MCF5235 Chip Errata

Silicon Revision: All

This document identifies implementation differences between the MCF523x processors and the description contained in the *MCF5235 ColdFire® Reference Manual*. Refer to <http://www.freescale.com/coldfire> for the latest updates.

Figure 1. Buffer Overrun Example

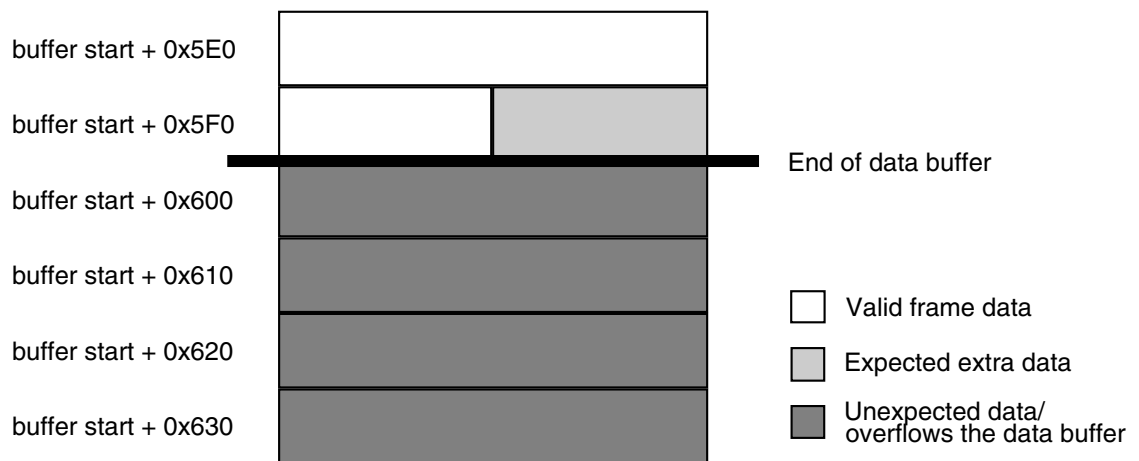
Description: When the FEC is connected to a 10BaseT network, if length of the data stored in a descriptor is not evenly divisible by 16 (not line-aligned), the FEC writes extra lines at the end of the buffer. The entire line that contains the last valid data is written and at least one extra line, but up to four lines after the end of the valid data can also be written. In most cases, this is not a problem because the extra lines of data continue falling within the limits of the buffer. However, if the valid data ends near the end of the buffer, the extra lines written by the FEC might be outside of the data buffer. This leads to corruption of the next buffer, descriptor, data, or code stored in the adjacent memory.

For example, as shown in the figure below, if the max buffer size is programmed to 0x600 and a frame that is 0x5F8 bytes long is received, a line is written starting at buffer start + 0x5F0. The first half of the line at buffer start + 0x5F0 is valid frame data that should be processed by the FEC driver; the second half of the line is additional data that is written because the FEC only writes complete lines. This data should be ignored by the FEC driver. So far, this is correct FEC behavior as originally specified. However, the FEC repeats the last line of valid data a number of times. The line at buffer start + 0x600 is written, and as many as three additional lines beyond the end of the data buffer could be written.

Workaround: Allocate extra lines for the receive data buffers. The actual allocated memory for each buffer should be equal to the receive buffer size programmed in the FEC's EMRBR register plus four lines (16 byte-sized lines).

Workaround: Program the data buffer size one line larger than the max packet size (data buffer size = EMRBR + 0x40).
